# Certificate of Appropriateness

**1139 E. KNAPP ST. First Ward Triangle Historic District**

PTS ID 94059 COA, exterior restoration

HISTORIC IMAGE OF HOUSE WITH CLAY TILE ROOF. FLASHING AT ROOF MUST BE RECEIVERS TO ACCEPT CLAY TILE ROOF FLASHING IN FUTURE.

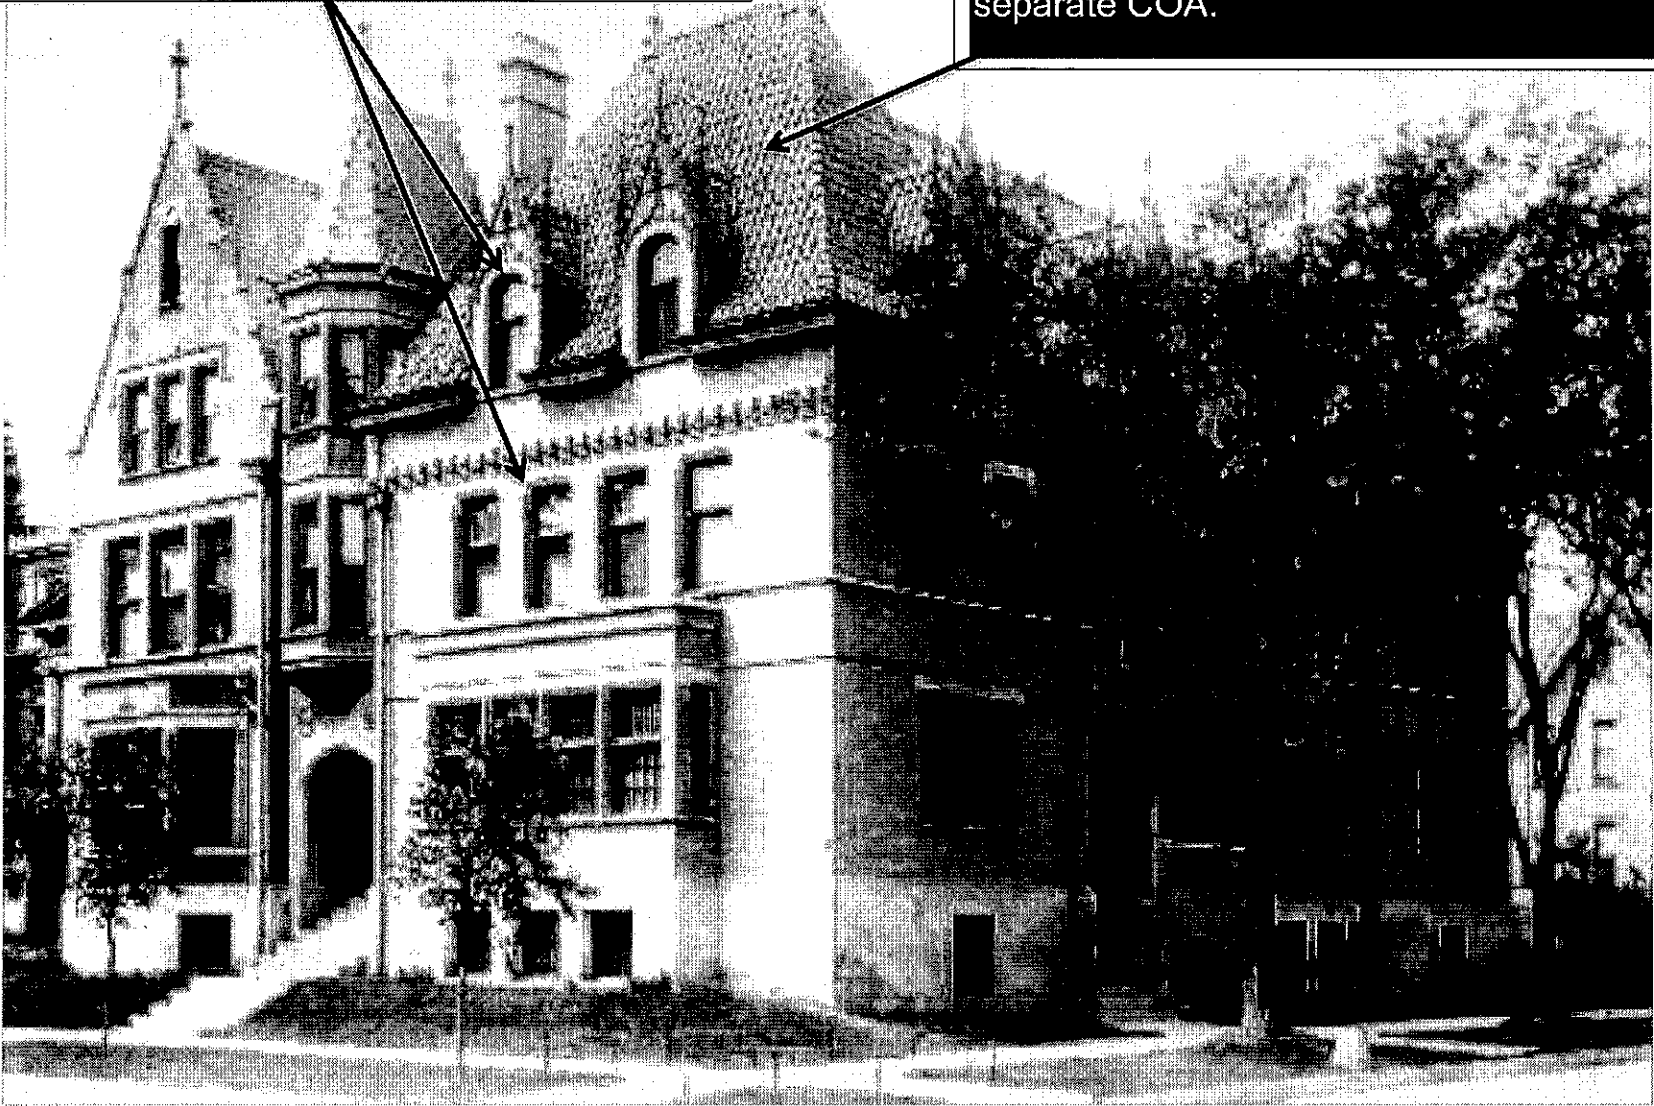
This central bay on 2<sup>nd</sup> and third stories to be rebuilt using original materials. Lintels on second floor will be re-used or made from new Bedford stone to match exactly the original pieces

Historic photo showing the house in original condition. The red clay tile roof pictured here will be duplicated and installed at a later date under a separate COA.

12 Elevation 3 - b  
1/4" = 1'-0"

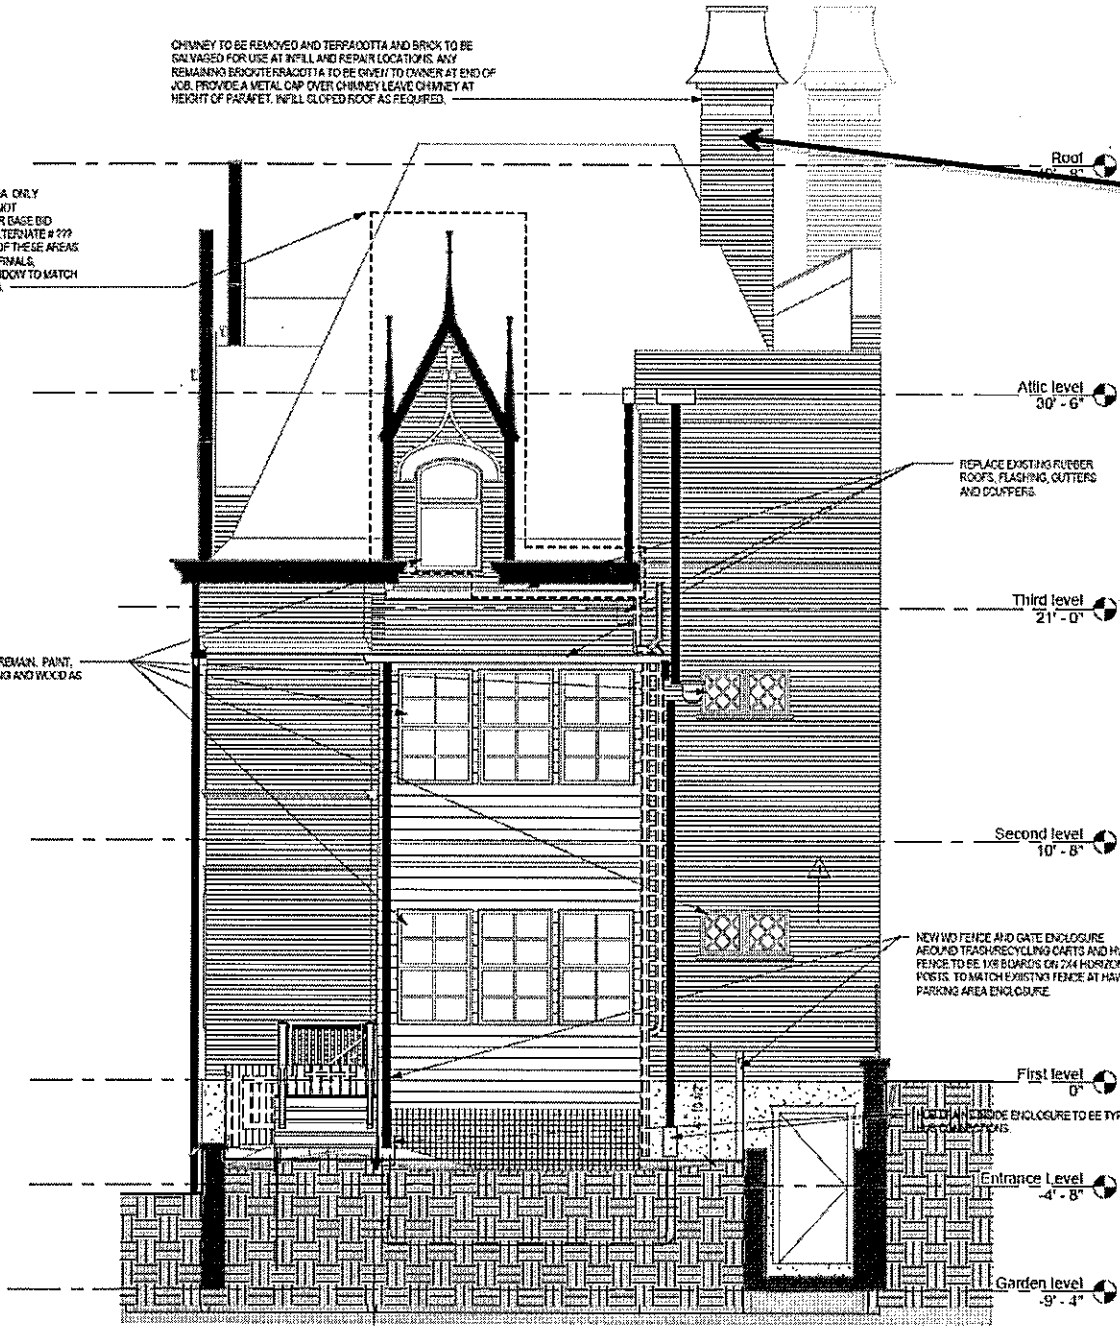
**Stoop to be installed at rear of house on Knapp Street elevation.**

③ PHASE 1 - WEST ELEVATION - NEW  
1/4" = 1'-0"

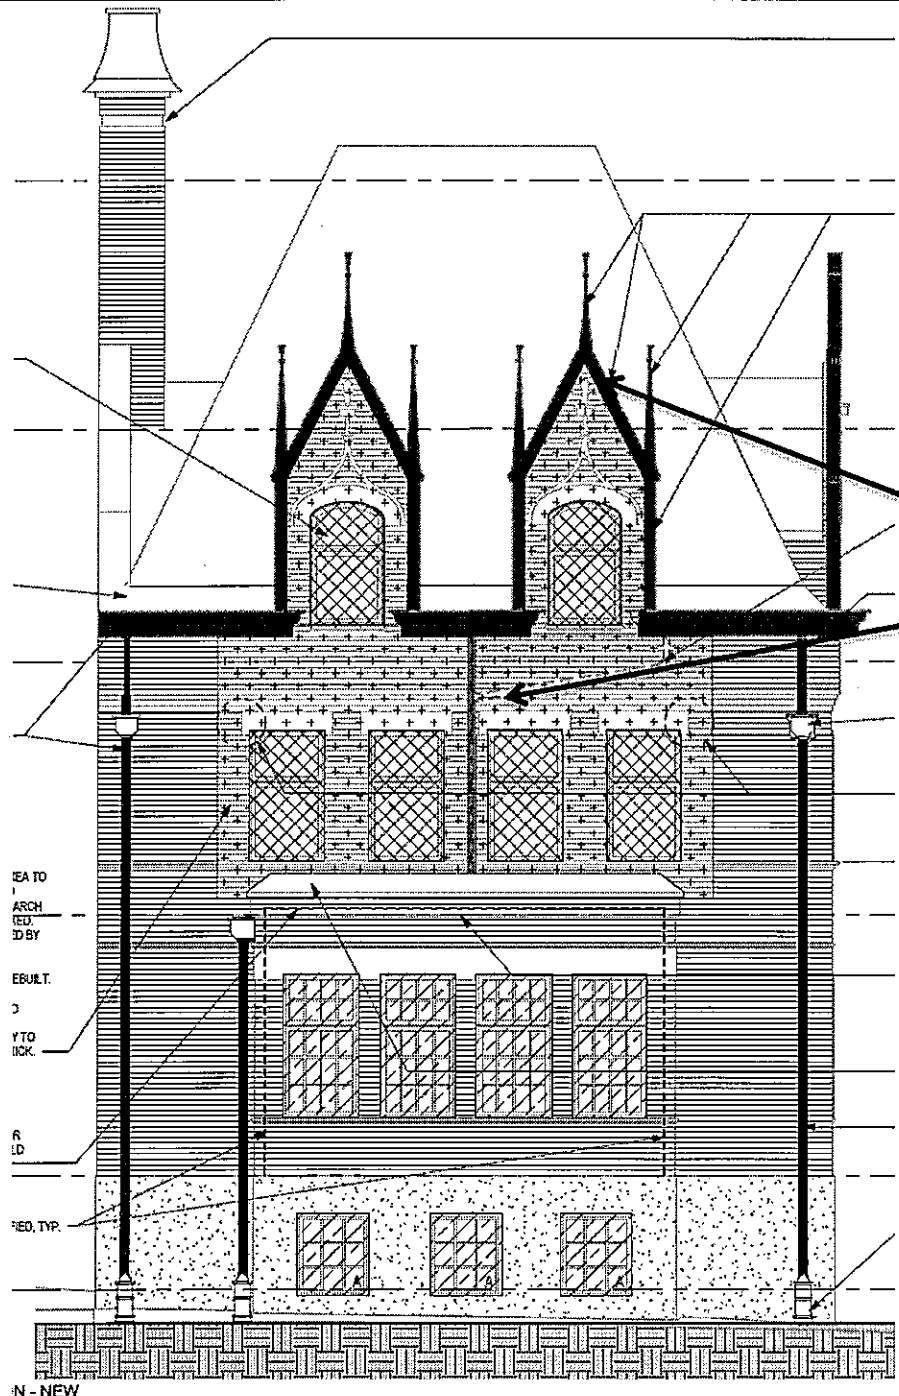
**Remove rear chimney only in order to salvage brick for rebuilding front bay**

East elevation

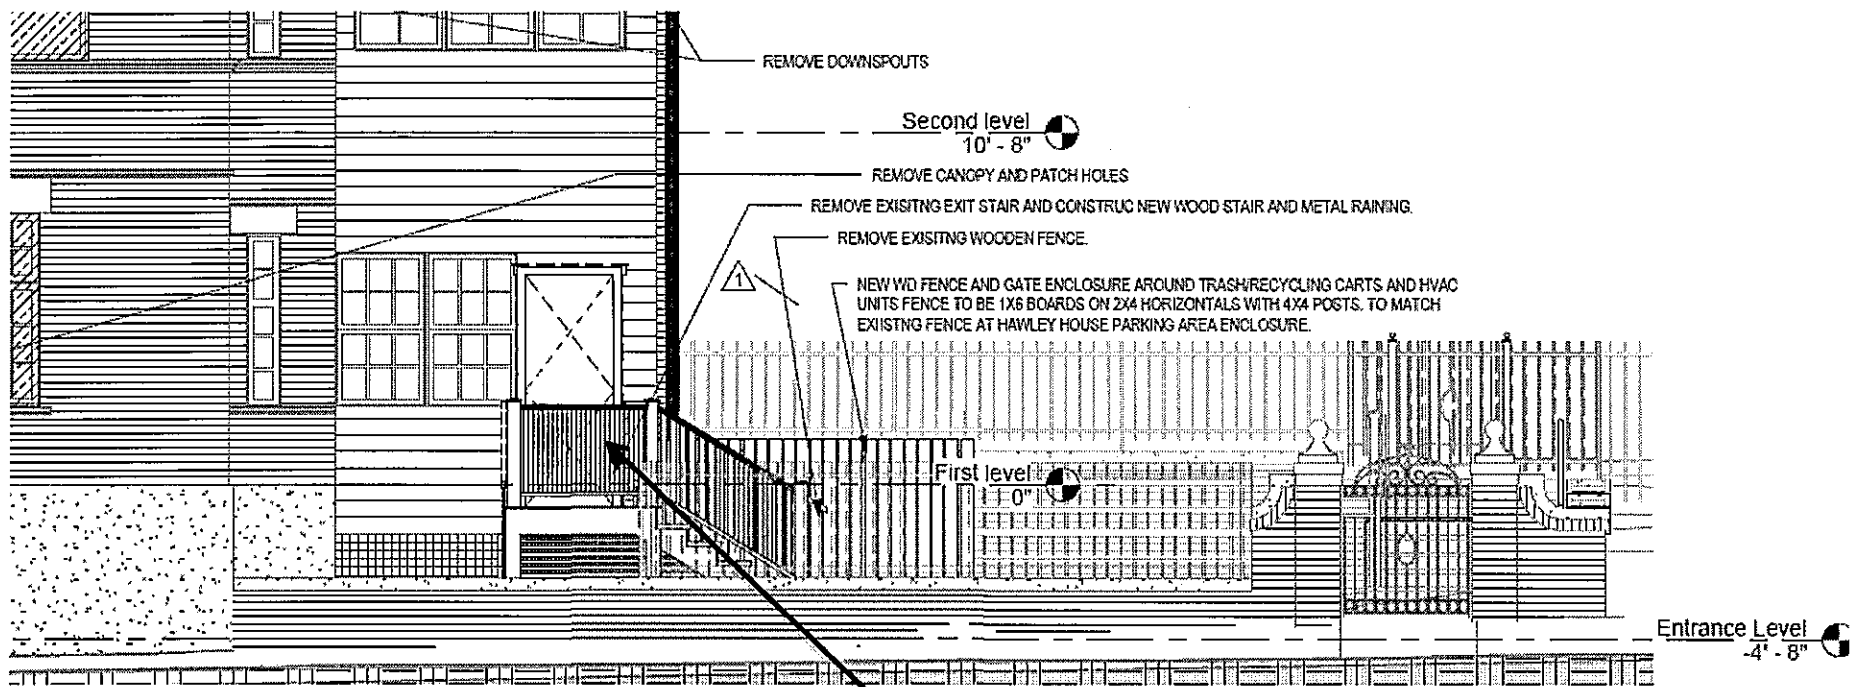
Brick in this area to be removed and re-layed with new structural elements and windows to be replaced using either originals or all-wood replacement to match exactly the original glass sizes and profiles of all moldings. Glass must be clear. No low-e or tinted. Gable surrounds will be rebuilt in copper to match exactly the originals including all crockets and finials.

13 Elevation 3 - c  
1/4" = 1'-0"

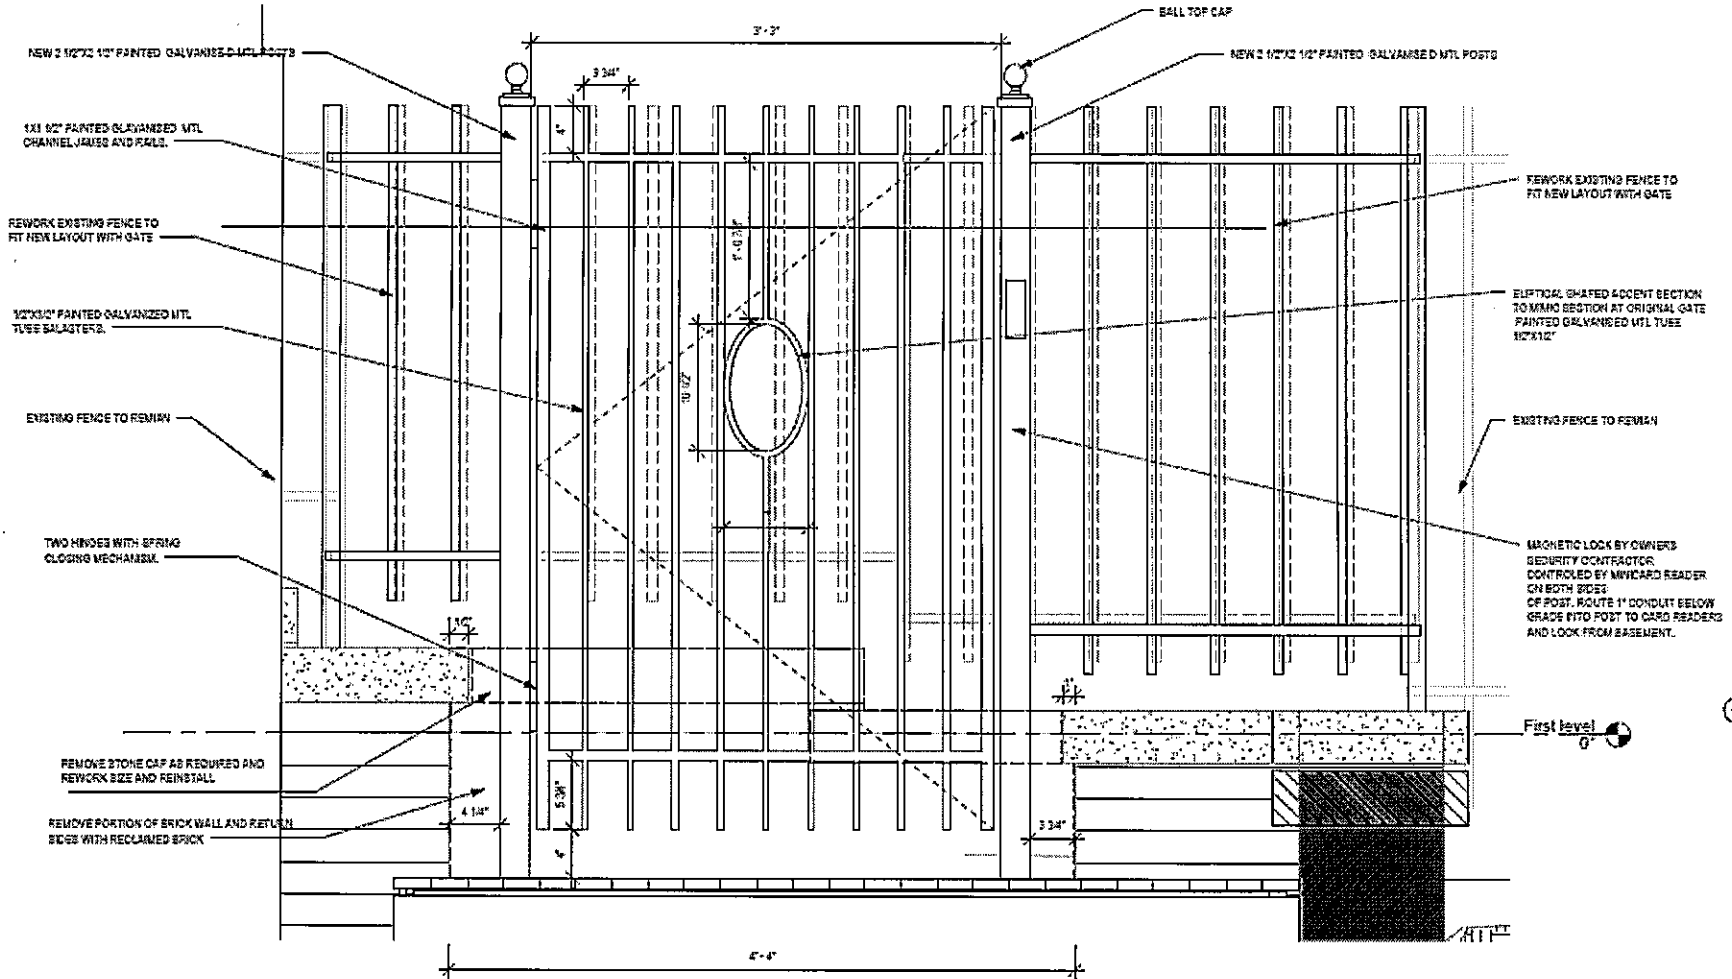
**New stoop and steps for backyard**

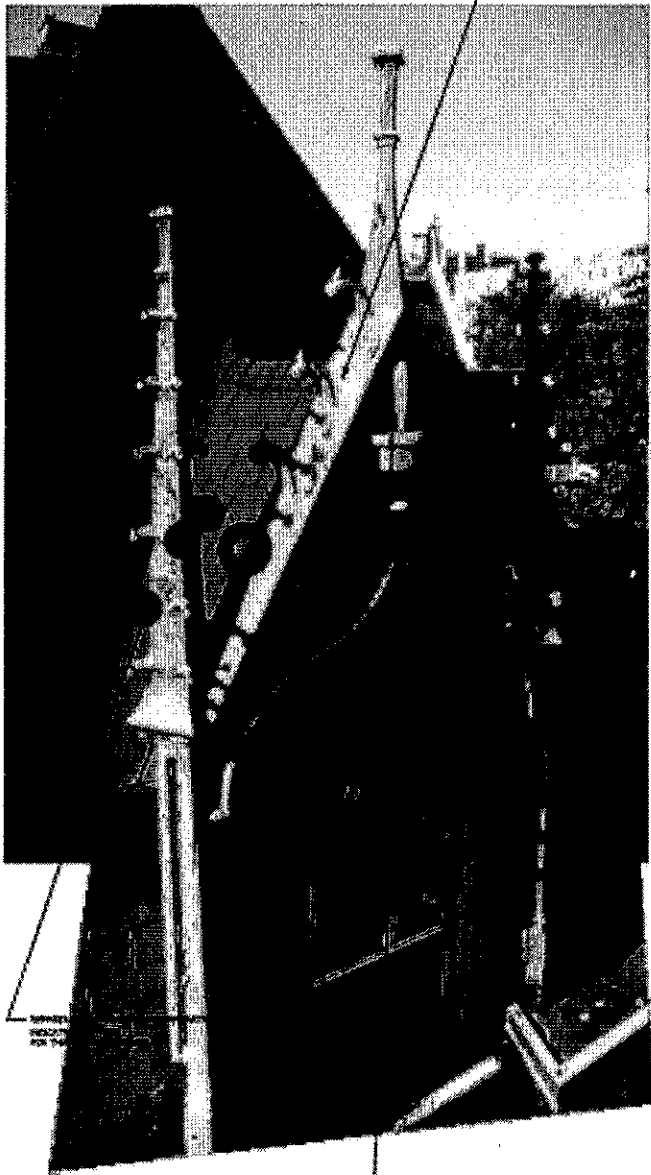
**Detail of steel gate in rear yard.**
